UTILITY PLAN

**HARBISON AUTO SALES**  
2027 SOUTH LAMAR BLVD.  
AUSTIN, TEXAS

REPLACEMENT SHEET

SP-03-0469C

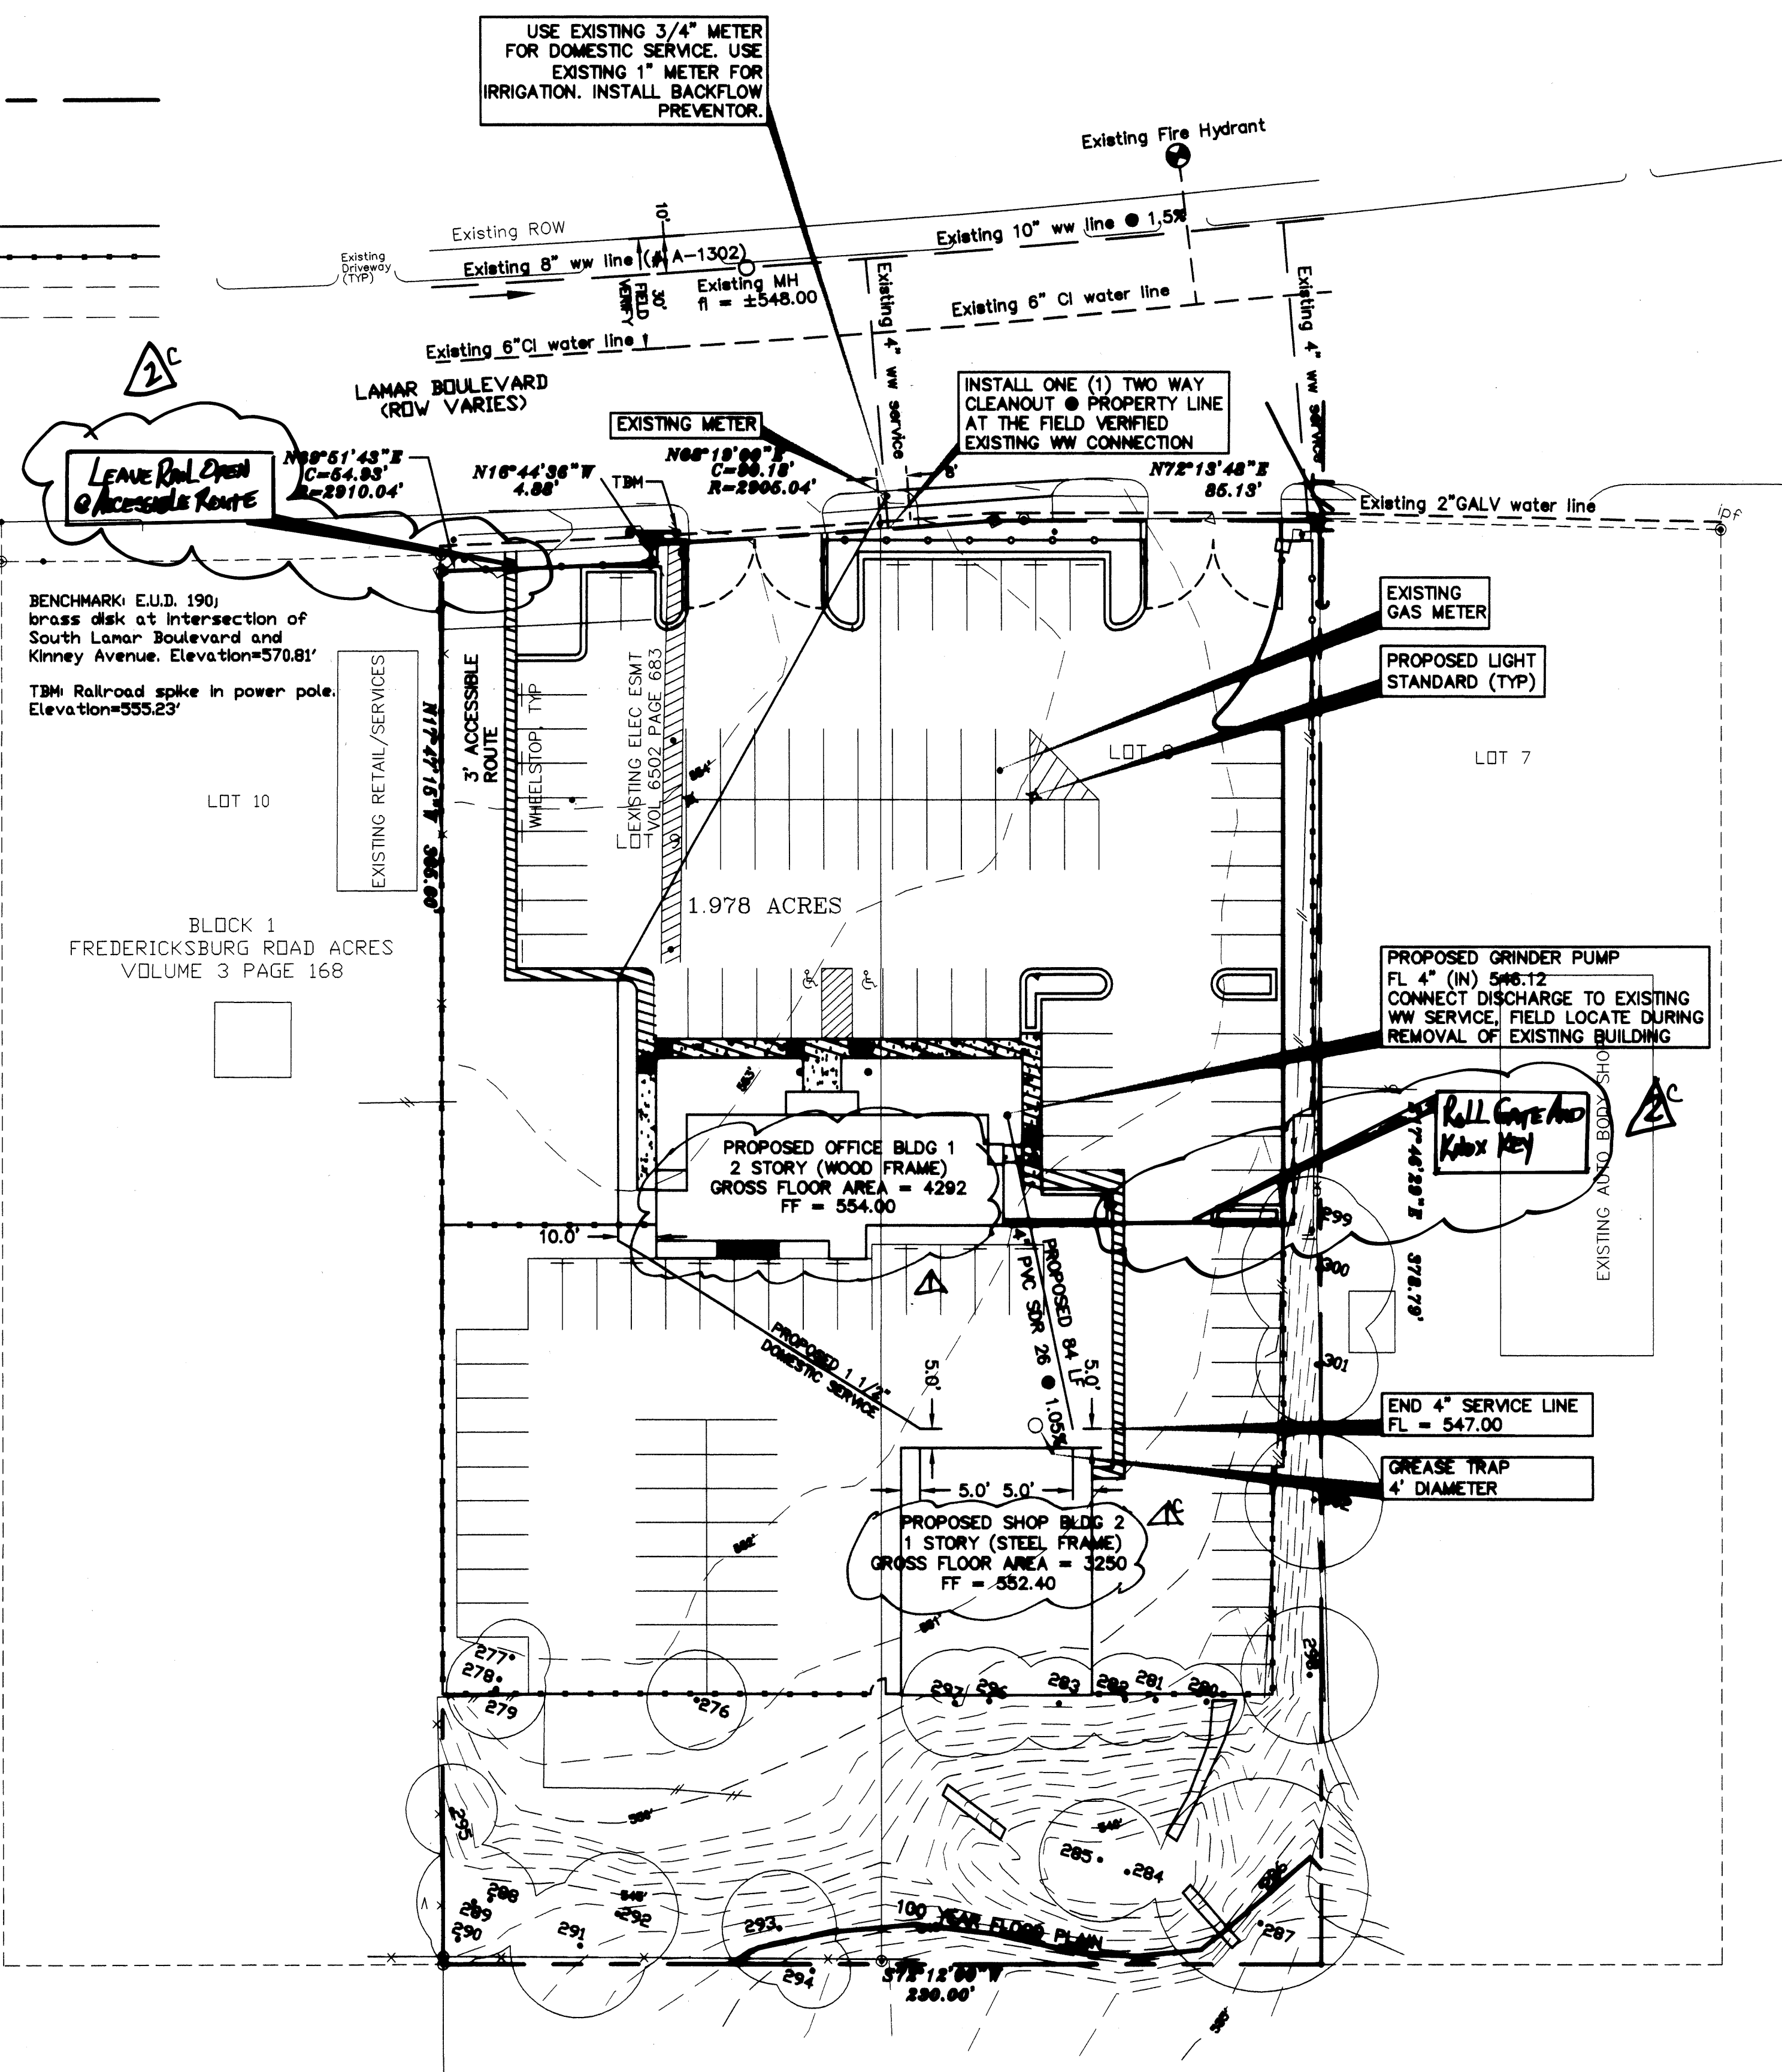
7-25-08	REV	DATE	BY	APP	COMMENT
7-9-04	KEY	DATE	BY	APP	BLDG 2. ADD EXTERIOR STAIRS
